Access Compliance Report

Public Rights-of-Way

(Curb Ramps)

Intersection ID: 25705	Main Street: REA_RD	Cross Street: SUNDANCER_LN	Location: NE
ADA ID: 7F8BCB9A91B4	Ramp Type: Perp	Initial Pass/Fail: Fail	Overall Compliance: No
Severity Score: 13.75			
Codes/Mitigation Info/Possible Solution		Field Measurements/Component Compliance

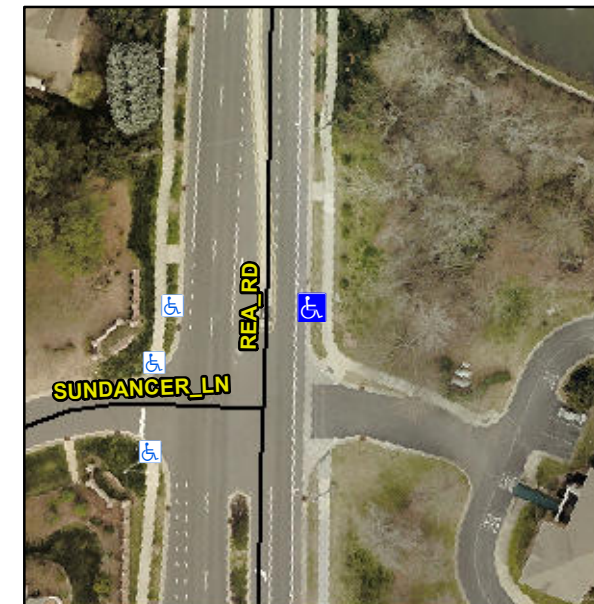
Not Found, R304.2.2, R304.5.3

Compliance	Description	Data	Compliance	Description	Data
N/A	Ramp Length (in)	72.0	No	Ramp Slope (%)	8.5
Yes	Ramp Width (in)	82.0	No	Ramp XSlope (%)	4.4
N/A	Flare Type LT	N/A	N/A	Flare Type RT	N/A
N/A	Flare Slope LT (%)	N/A	N/A	Flare Slope RT (%)	N/A
N/A	Flare Traversable LT?	N/A	N/A	Flare Traversable RT?	N/A
N/A	Landing Length (in)	N/A	N/A	DWS Provided?	N/A
N/A	Landing Width (in)	N/A	N/A	DWS Contrast?	N/A
N/A	Landing Slope (%)	N/A	N/A	DWS Length (in)	N/A
N/A	Landing X Slope (%)	N/A	N/A	DWS Full Width?	N/A
N/A	Landing Curb? (Y/N)	N/A	N/A	DWS Offset (in)	N/A
N/A	Shared Landing?	N/A			
N/A	Gutter Ponding?	N/A	N/A	Gutter Slope (%)	N/A
N/A	Gutter Lip Ht (in)	N/A	N/A	Gutter X Slope (%)	N/A
N/A	Painted X Walk1?	No	N/A	Painted X Walk2?	N/A
	X Walk 1 Direction	To W		X Walk 2 Direction	N/A
N/A	X Walk 1 Width (in)	N/A	N/A	X Walk 2 Width (in)	N/A
	X Walk 1 Slope (%)	2.3		X Walk 2 Slope (%)	N/A
	X Walk 1 X Slope (%)	3.3		X Walk 2 X Slope (%)	N/A

N/A	Ramp inside XWalk1?	N/A	N/A	Ramp inside XWalk2?	N/A
	Road Slope (%)	N/A	N/A	Clear Space?	N/A
	Road X Slope (%)	N/A	N/A	Clear Space to XWalk (in)	N/A
N/A	Any Obstructions?	N/A	N/A	Storm Grate/Utility Hazard?	N/A
	Obstruction Type			Storm Grate/Utility Type	
		N/A			N/A
			Yes	Surface Condition? (G/P)	Good

Remove & Replace Entire Ramp.
